ROBERT E. GINNA NUCLEAR POWER PLANT

CONTAINMENT VESSEL EVALUATION

PREPARED FOR  
ROCHESTER GAS AND ELECTRIC CORPORATION

PREPARED BY  
GILBERT/COMMONWEALTH  
READING, PENNSYLVANIA

FIGURE 2 .. ACCIDENT PRESSURE LOAD TRANSIENT IN THE CONTAINMENT

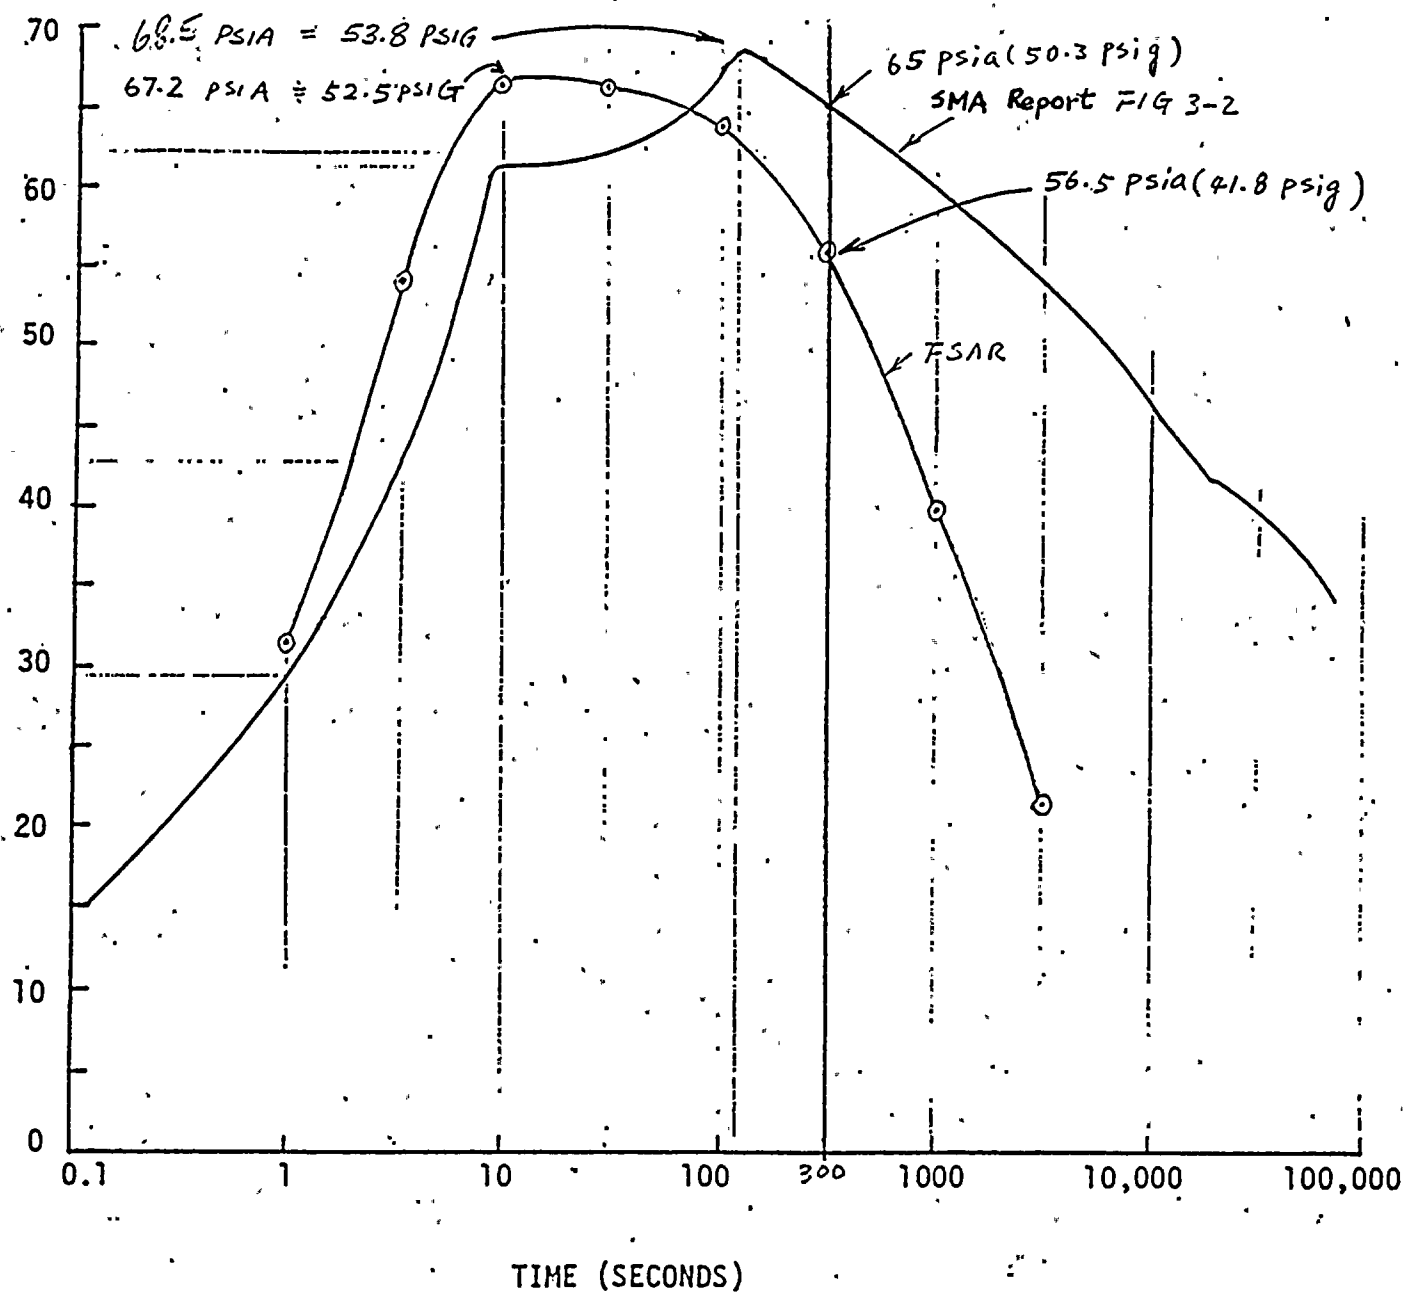
1. The accident pressure curve used in SMA report is different from that presented in the FSAR. Attached Figure 2 shows a comparison between the SMA report pressure curve and the Double Ended (D.E.) break pressure curve appearing in FSAR Figure 14.3.4.2. The peak values from both curves are about the same: 68.5 psia (53.8 psig) from SMA and 67.2 psia (52.5 psig) from the FSAR. The FSAR curve

decays more rapidly than the SMA curve. As an example, at 5 minutes into the accident the FSAR value is about 56.5 psia (41.8 psig) compared with the SMA value of 65 psia (50.3 psig). The peak pressures from both the SMA curve and the FSAR curve are less than the Ginna Design Pressure of 60 psig.

FIG. 4: ACCIDENT TEMPERATURE DISTRIBUTION  
IN THE STEEL LINER

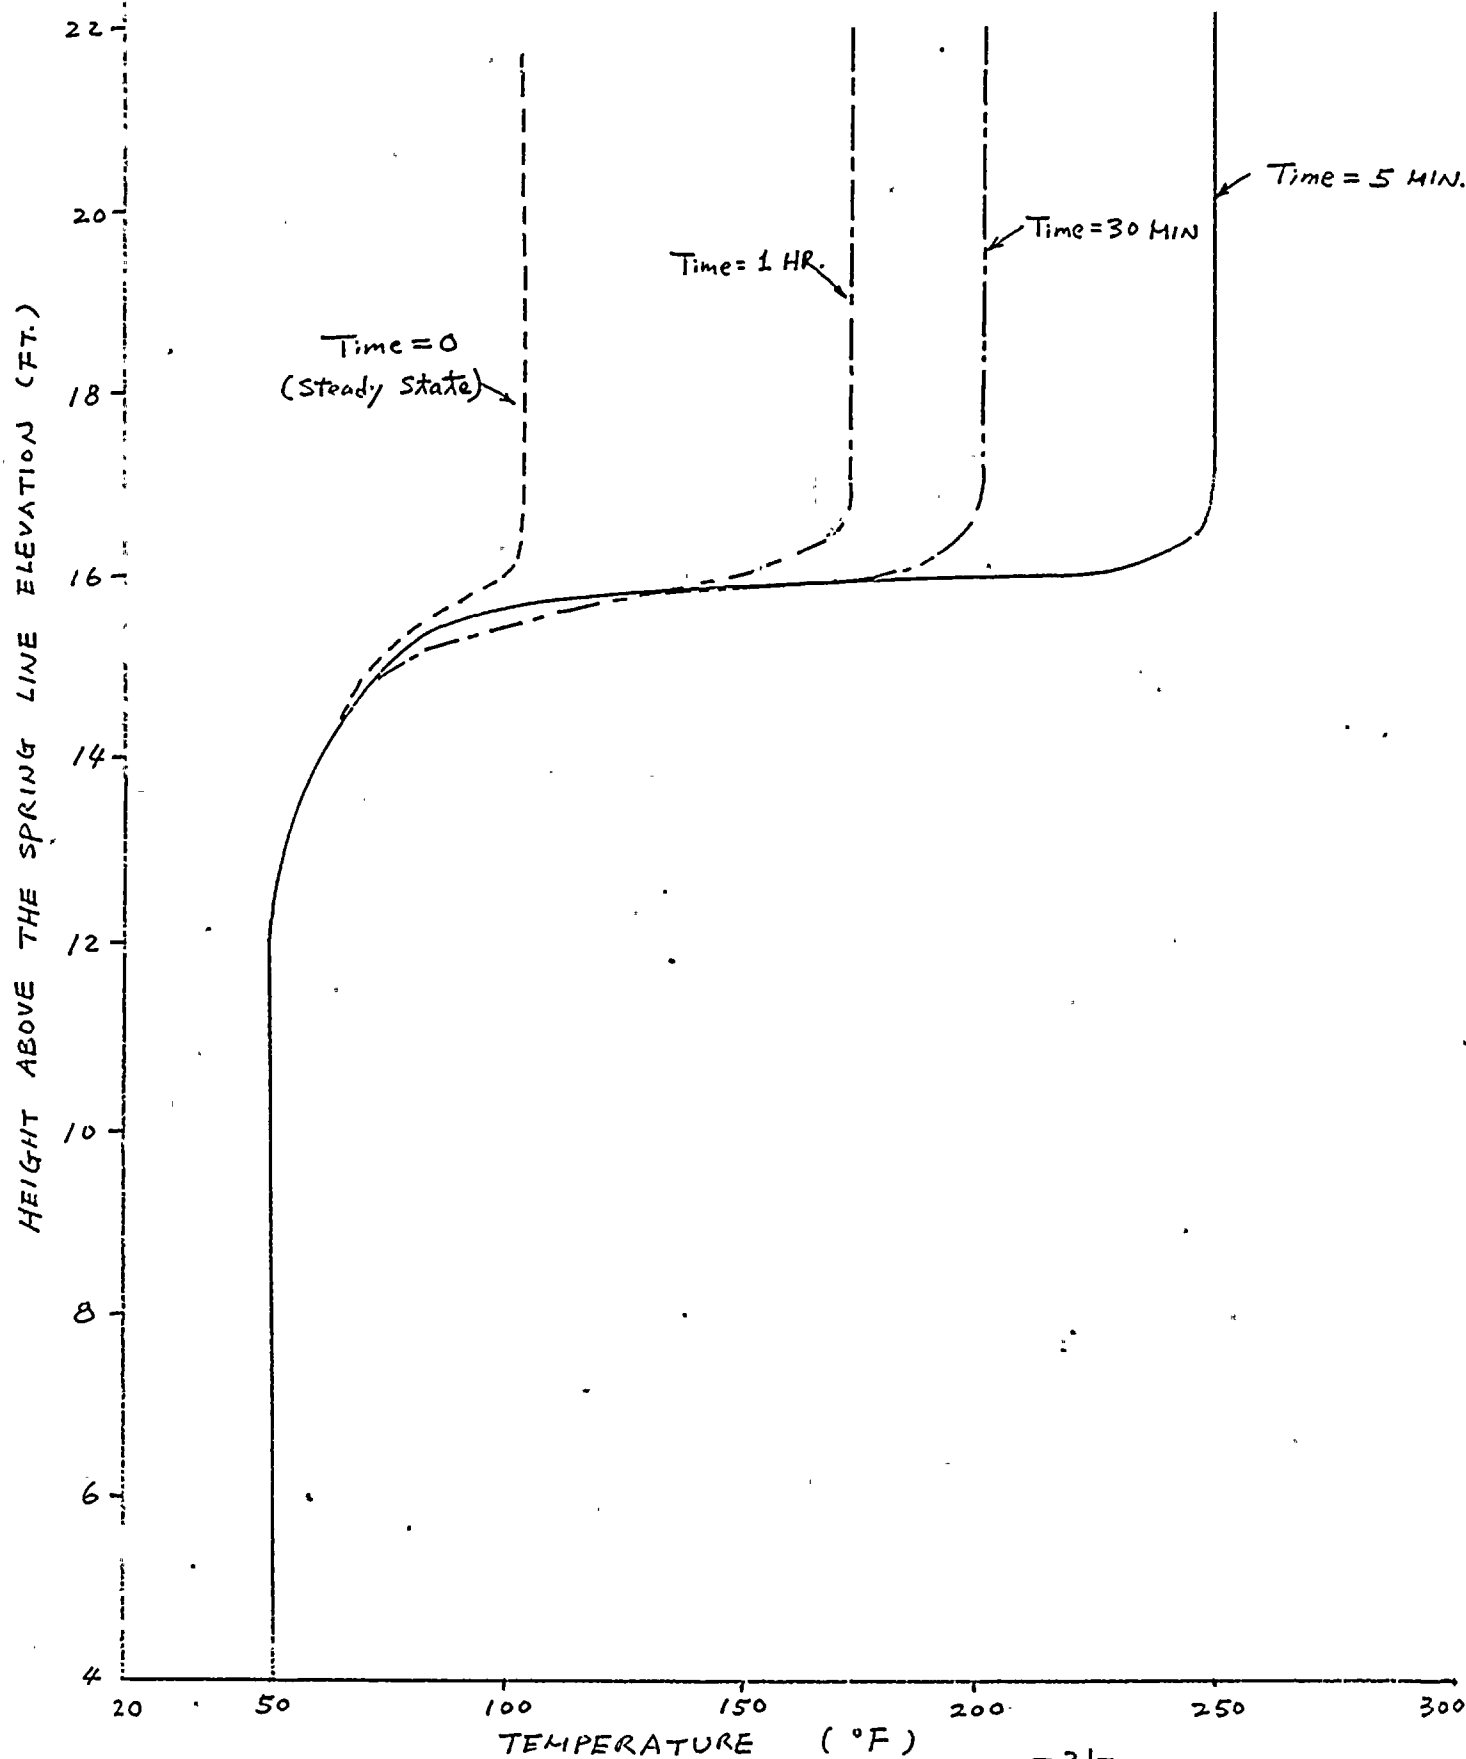
In order to determine the most severe temperature distribution in the shell wall, G/C conducted a heat transfer analysis (Reference 4) considering the film coefficient effect. Figure 4 shows part of the analysis results. It indicates that the uninsulated steel liner would reach a peak

temperature of 250° F at about 5 minutes into the accident. Accordingly, the associated temperature distribution in the wall at this time was used in the stress analysis.

FIG. 5: MERIDIONAL STRESSES IN LINER FOR  $T_a$

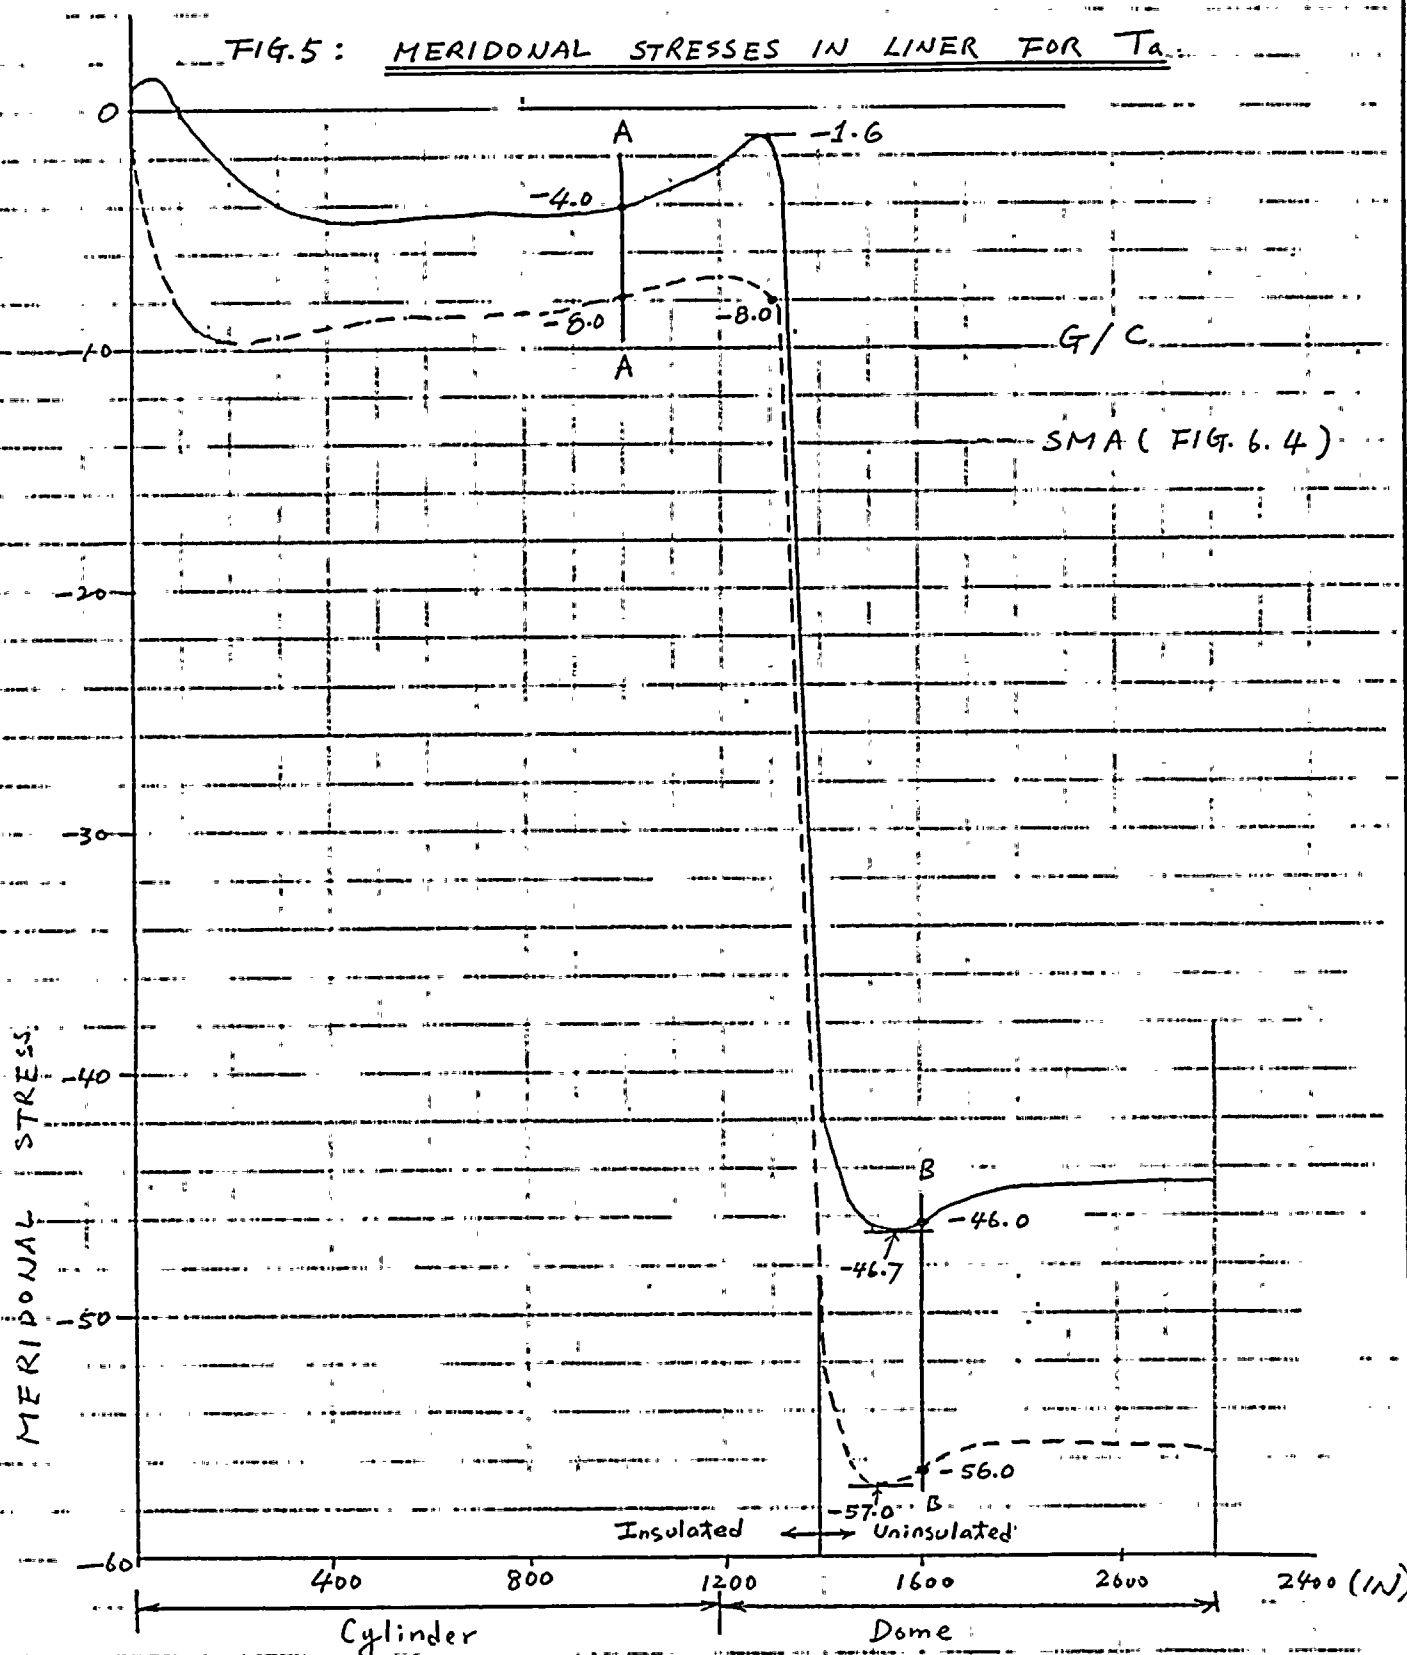
Figures 5 to 12 provide the curves which compare G/C and SMA results for liner and concrete stresses. It is seen that the trends of the results are very similar to each other. However, there are differences in values. Generally, G/C obtained comparatively lower stresses. This is expected since the pressure and temperature values used in the G/C analysis are less than those used in the SMA analysis. Table 1 lists the values of the meridional and circumferential (hoop) stresses for different locations and loading cases. From the table, the compressive stress in the uninsulated dome liner for combined accident temperature and accident pressure loads is 42.7 ksi which is about 20% less than the SMA value of 52.1 ksi. The maximum concrete stress is 4.2 ksi compression from the G/C analysis versus 6.0 ksi compression from the SMA analysis.

From the G/C results in Figures 5 and 6, the minimum compressive stress in the liner behind the insulation for the accident temperature condition is 1.6 ksi compression. The unbalanced liner stress in the region is  $29 - 1.6 = 27.4$  ksi, and this develops a significant shear force acting at the insulation termination interface. The unbalanced force is transmitted to the liner and studs behind the insulation. The shear force and displacement developed in the studs largely depend on the value of unbalanced liner stresses, the material properties of liner and the characteristics of stud force-displacement relationship. Based on the equilibrium and compatibility relations at each stud, a set of simultaneous equations are derived, from which the stud displacements and forces are solved by iteration on the stud displacements (Reference 5).

FIG. 13: THE MODEL AND RESULTS OF STUD ANALYSIS

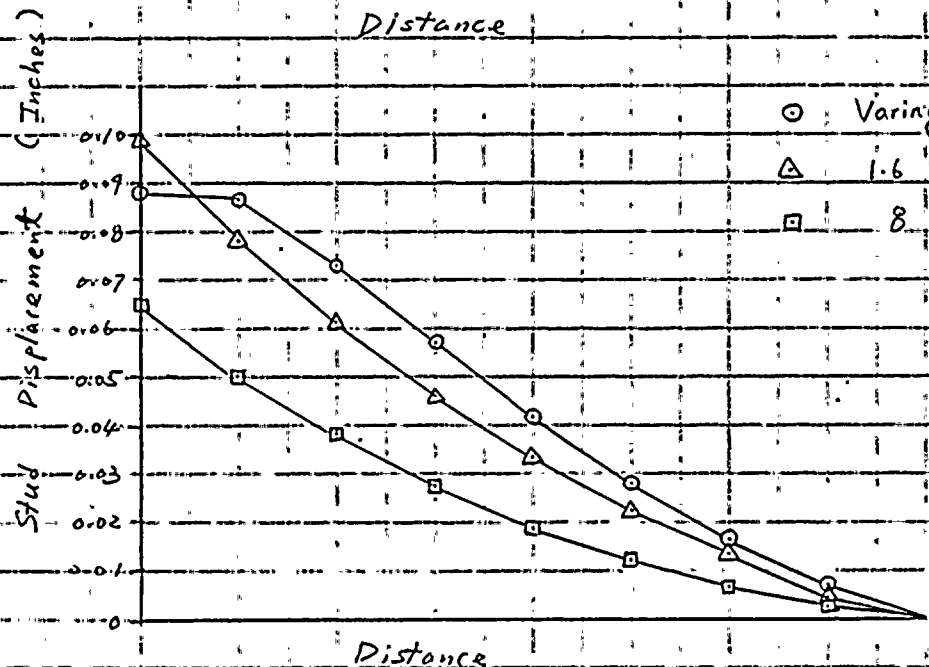
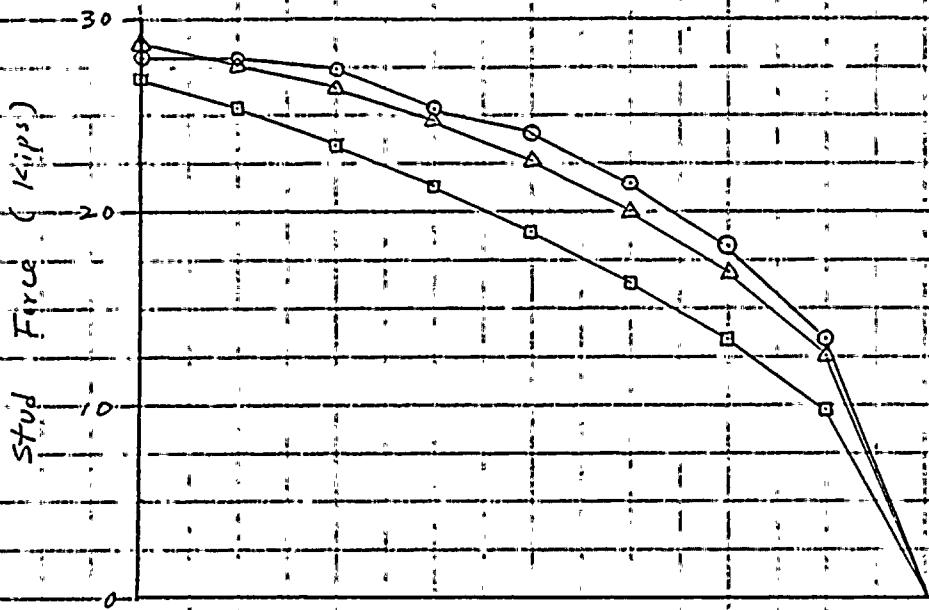
The stud-liner structure is represented by a simplified one dimensional system as shown in Figure 13. The width of the liner panel is taken to be 24 inches, which is the stud spacing. One end of the liner is fixed approximately 16 feet from the buckled panel, which is the location of embedded channels at the shell springline (see Figure 1). At the other end a force exists which corresponds to the post-buckling stress 29 ksi. This condition results in movement of the studs in the adjacent panels with the largest displacement occurring adjacent to the panel where post-buckled stress is applied (Stud #1). The steel liner is represented as a linear elastic material with Young's modulus  $E = 29,000$  ksi. The force-displacement relationship for the studs is obtained from the experimental results provided in Reference 6. From this reference, the force-displacement relationship can be represented by the empirical equation  $Q = Q_u (1 - e^{-18\Delta})^{2/5}$  (see Figure 14). In this equation  $\Delta$  is the stud displacement;  $Q$  is the corresponding stud force; and  $Q_u$  is the ultimate stud capacity which is calculated to be 31.1 kips from Equation (3) of Reference 6 for a 3/4 inch diameter headed stud.

Figure 13 presents the comparison of the stud analysis results corresponding to three initial stress cases. The maximum stud force and stud displacement for each case are listed in Table 2 along with the ultimate stud capacity and the allowable stud displacement. The allowable displacement of a stud is limited by Table CC-3730-1 of the ASME Code (Reference 7) to 50% of its ultimate displacement for displacement limited loads. The load on the studs under consideration are classified as displacement limited loads since they are primarily due to the accident temperature condition. A value of 0.30 inches was used for the ultimate displacement of the 3/4 inch diameter by 3 inch long studs specified for the dome liner. This value is based on the test results presented in Reference 8. Therefore, an allowable displacement of 0.15 inches appears in Table 2.

It is noted that the maximum stud displacements for all three cases are within the Code allowable. Among them, the case of 1.6 ksi initial liner stress has the greatest values for stud displacement (0.098 inches) and force (28.9 kips).

- B. The conclusions of the SMA report regarding the structural integrity of the studs and the liner are not valid because the analysis neglects the interaction of the studs and the liner in transmitting the force in the buckled panel. The more realistic stud analysis performed by G/C indicates that the stud displacements and forces are within acceptable limits using either G/C or SMA liner stresses. The maximum stud force of 28.9 kips is less than its ultimate capacity of 31.1 kips, and the maximum stud

displacement is 0.098 inches which is within the ASME allowable of 0.15 inches. Therefore, it is concluded that stud integrity is maintained under accident temperature and accident pressure conditions.
